August 8, 2022

**Re: Winfield Subdivision Phase 9
Updated Review of Drainage Report and Construction Plans
Prepared by Oscar Castillo, P.E. including Updated Report**

**UPDATED REVIEW OF CONSTRUCTION PLANS
AND
DRAINAGE REPORT PREPARED BY
OSCAR CASTILLO, P.E., PEUA
FOR
WINFIELD SUBDIVISION – PHASE 9**

EXHIBIT #2

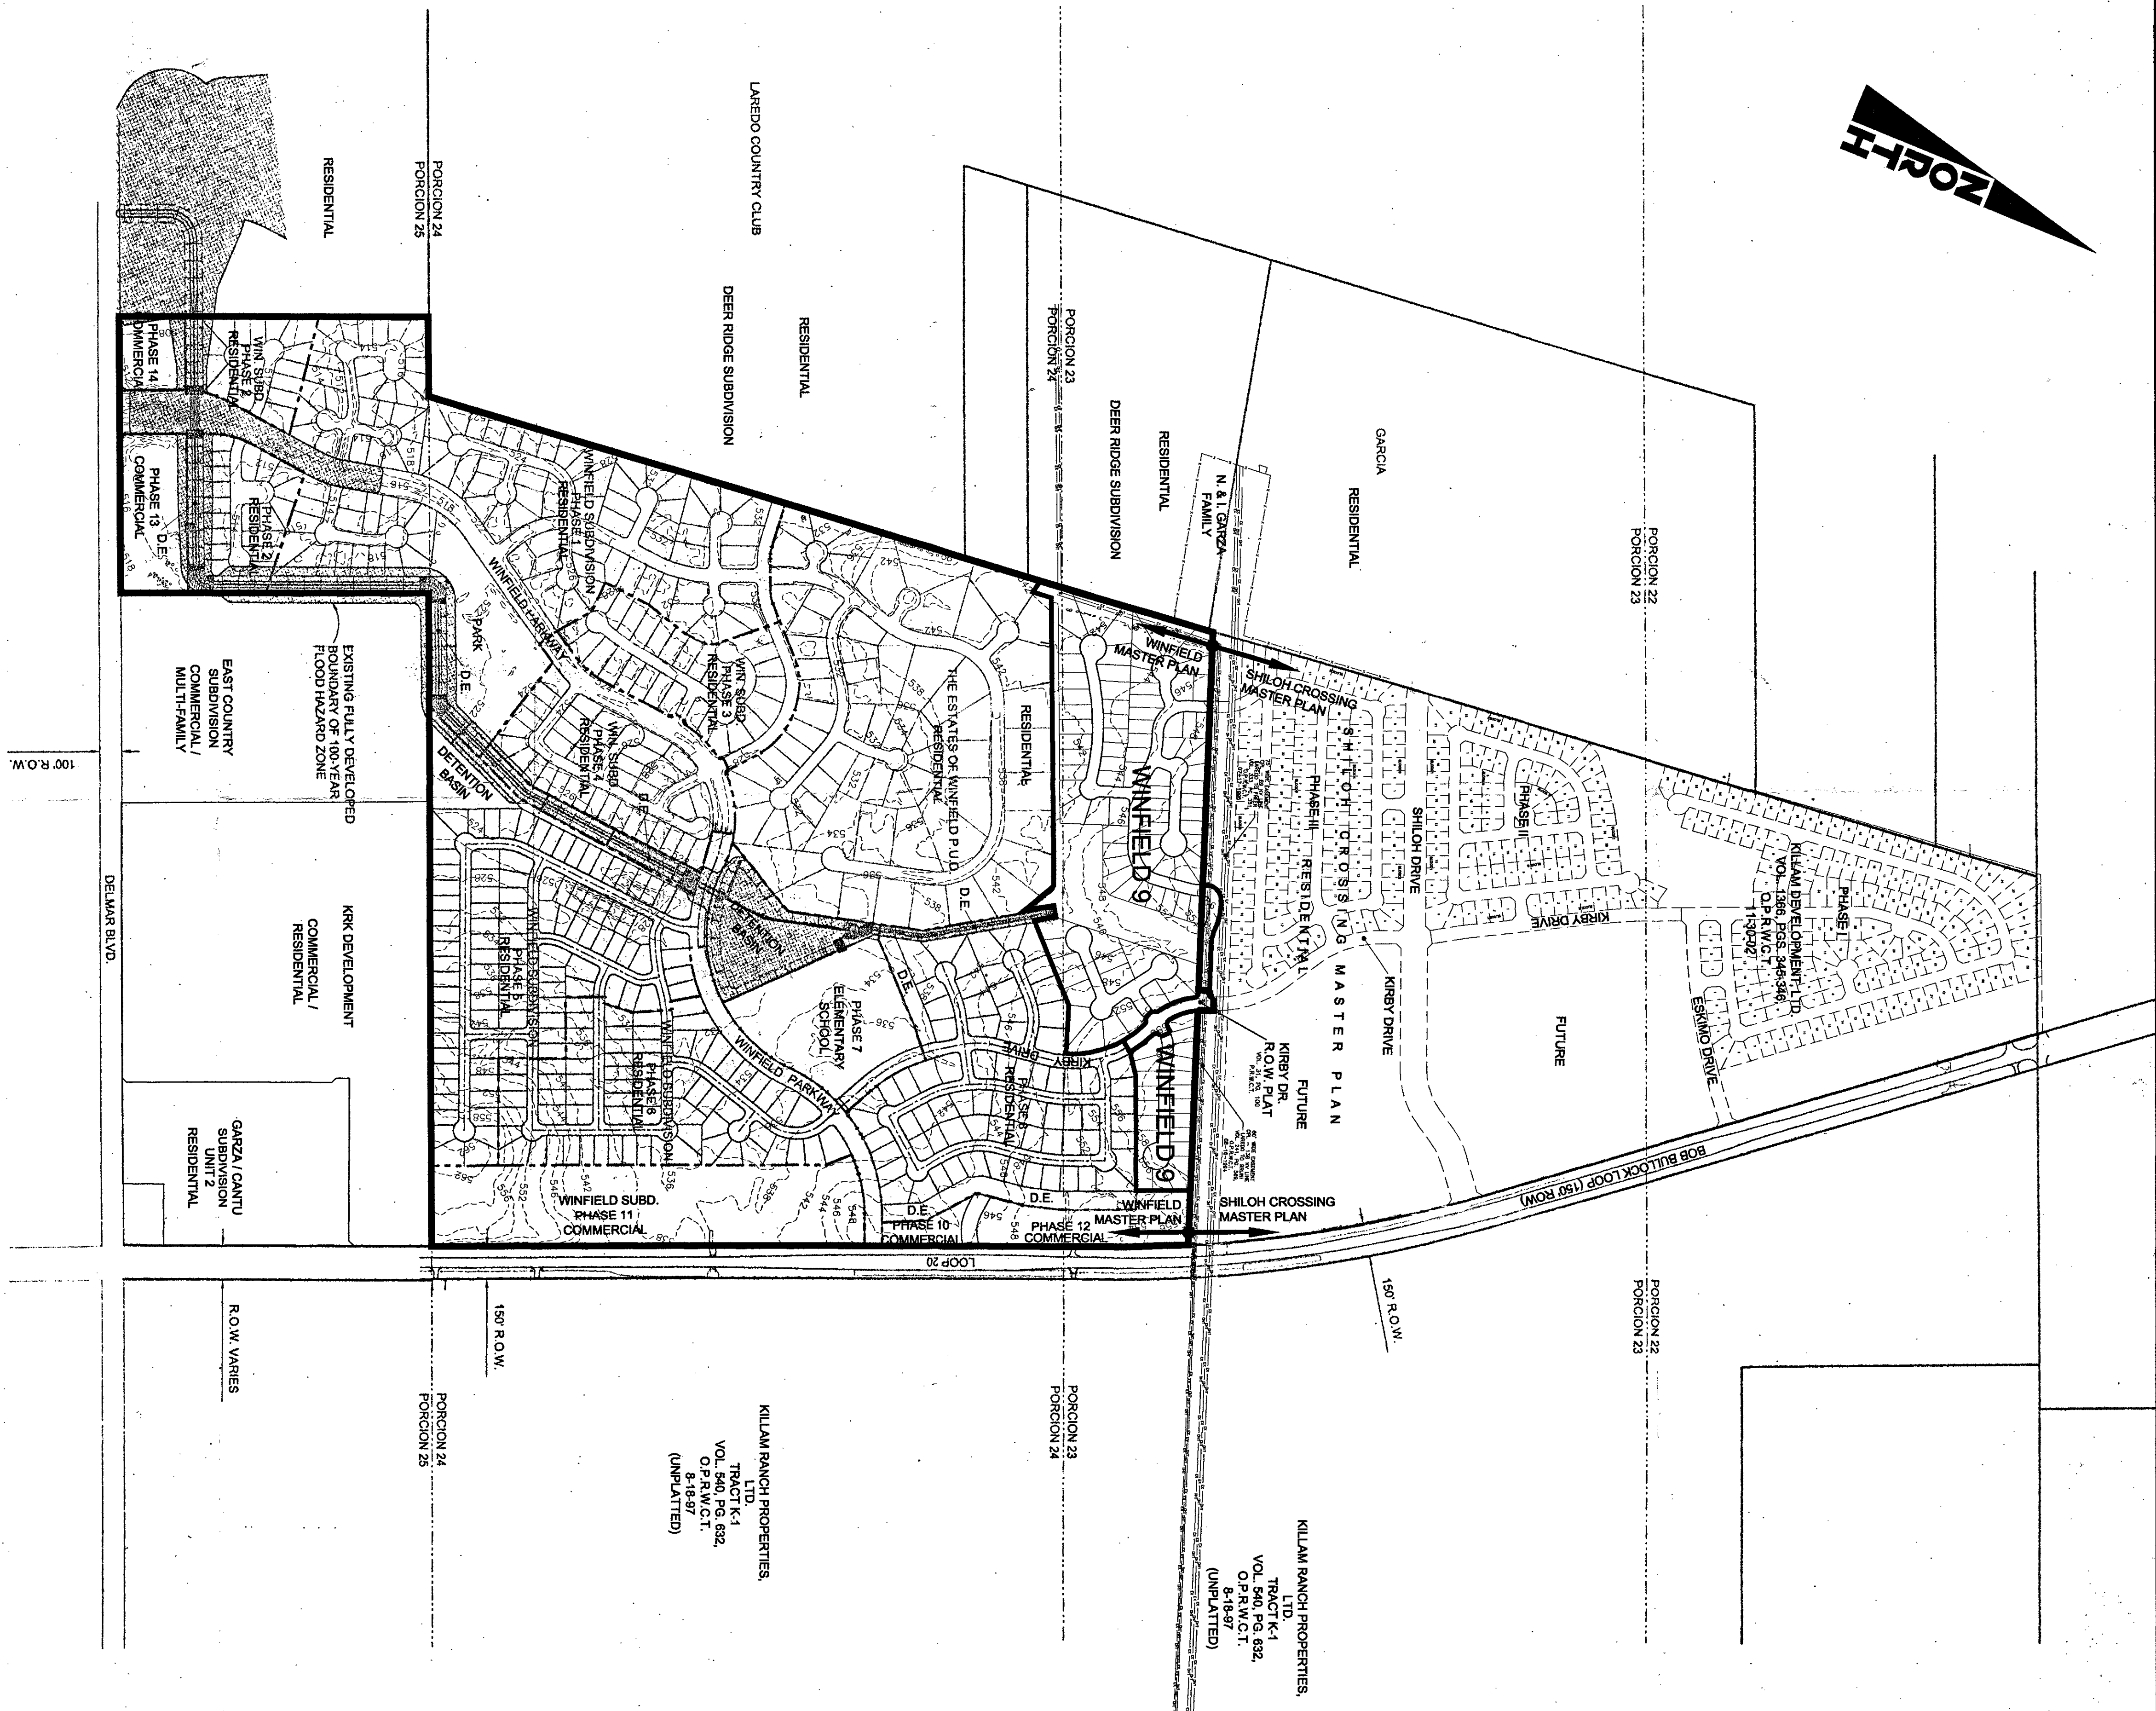
- 4.1 It is unknown if this masterplan was submitted and approved by the City of Laredo Planning and Zoning Commission;
- 4.2 Park was platted with Phase 1;
- 4.3 The lot layout for Phase 9 is different than PEUA's plat:
 - 4.3.1 Single family lots appear to backup to the Estates of Winfield PUD;
 - 4.3.2 There appears to be a gap between Phase 9 and the Estates of Winfield but it is not clear what this gap is for;
 - 4.3.3 There appears to be utilities running along the west side of Phase 9 which would address why there is a limited tract callout on Seca Engineering masterplan. A utility easement is typically used to reserve land for utilities.
 - 4.3.4 There appears to be a detention pond on Phase 9, but it's not called out.

It is recommended that the HOA reach out to City Planning Department to confirm if Howland masterplan was approved by the City. It is also recommended to reach out to Howland engineering to confirm what the gap between Phase 9 and the Estates of Winfield is for as well as confirming if the L shaped lot in Phase 9 masterplan is a detention pond site. If Seca masterplan was approved by the City, then we withdraw these recommendations as the Seca masterplan would replace the Howland masterplan.

Masterplan does not indicate any greenbelt but it does show park platted with Phase 1 similar to Harry Jewett Associates masterplan. Refer to Exhibit #2 for Howland Engineering masterplan.

EXHIBIT #3

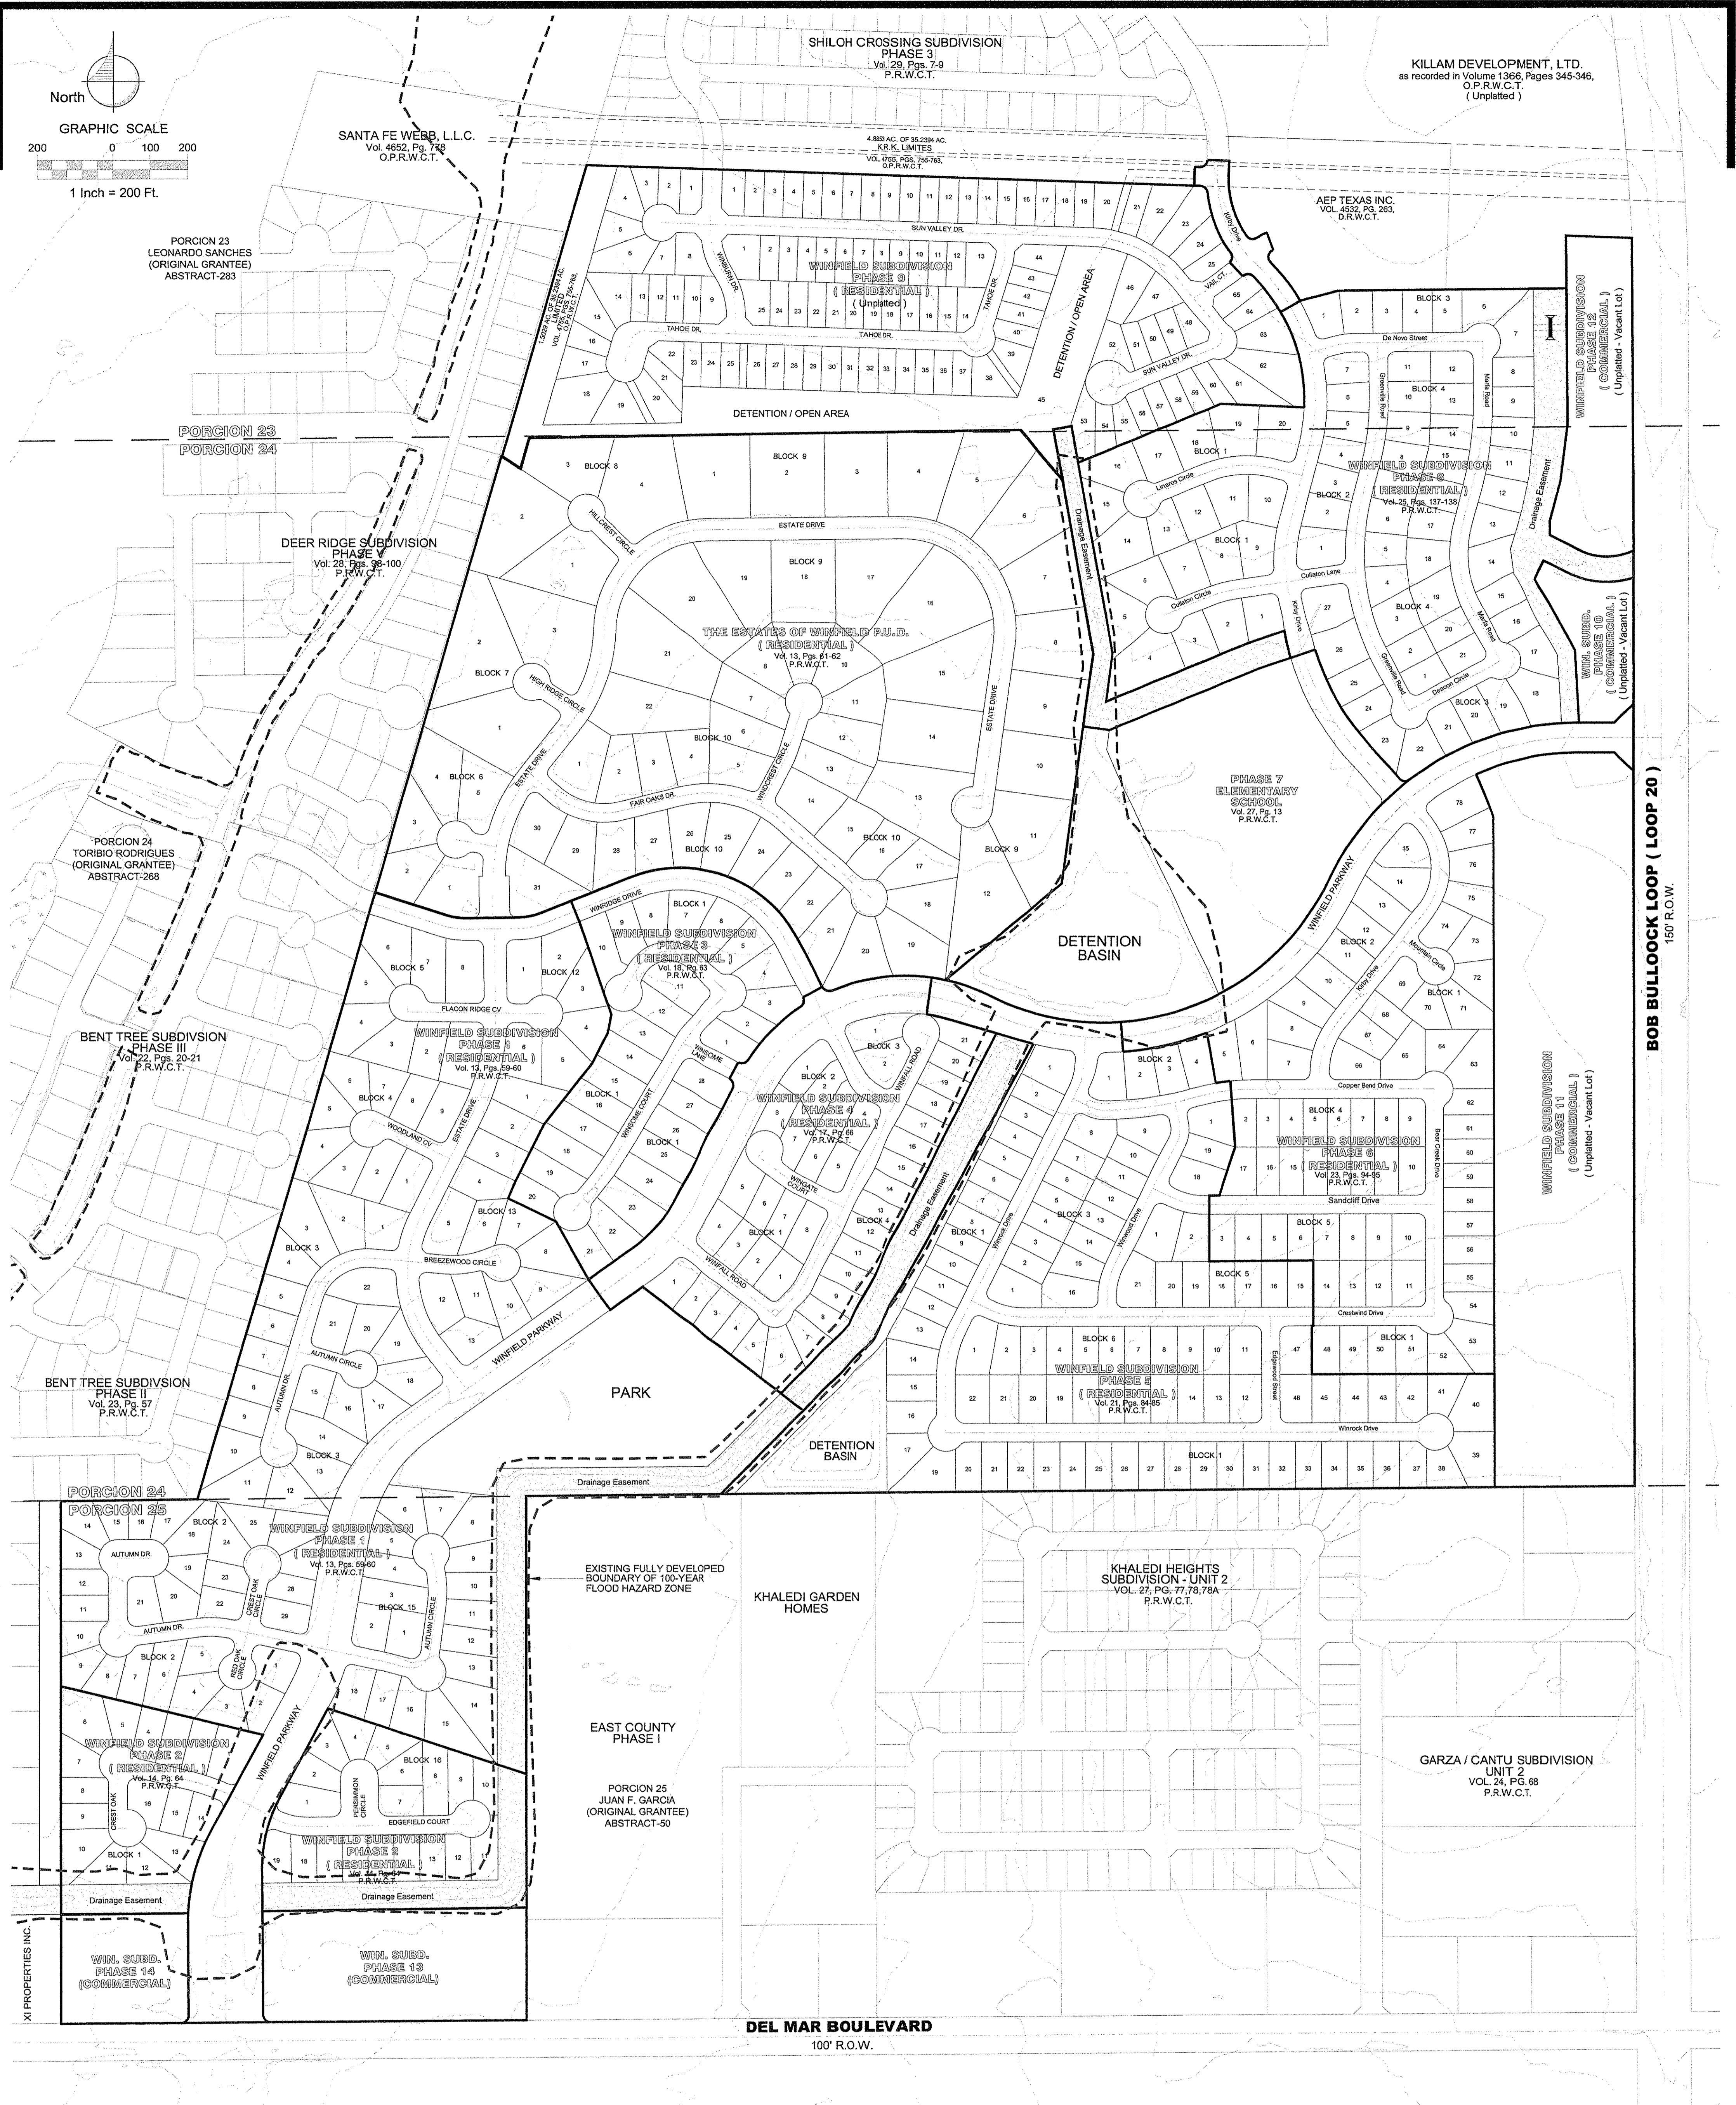
- 6.1 It is unknown if this masterplan was submitted and approved by the City of Laredo Planning & Zoning Commission;
- 6.2 Park was platted with Phase 1;
- 6.3 Phase 9 does not have a park component, but it does show detention pond / open area. Need to determine what open area means in this development;
- 6.4 Phase 9 lot layout on masterplan resembles plat prepared by Peua;

The Seca masterplan resembles the Phase 9 plat prepared by Peua. It is unknown if this masterplan was approved by the City of Laredo. The open area term on the masterplan for Phase 9 needs to be defined and explained what was the intent of this term as developers have used the term "open space" to mean park or greenbelt. It is not clear what is the intention of this masterplan and requires further investigation and clarification with the City and engineers who planned and designed this phase. Refer to Exhibit #3 for Seca Engineering masterplan and Exhibit #4 for Winfield Phase 9 Plat prepared by Peua.

We recommend to discuss this with the City Engineer and Planning Director to determine if Peua's plat is in compliance to the masterplan.
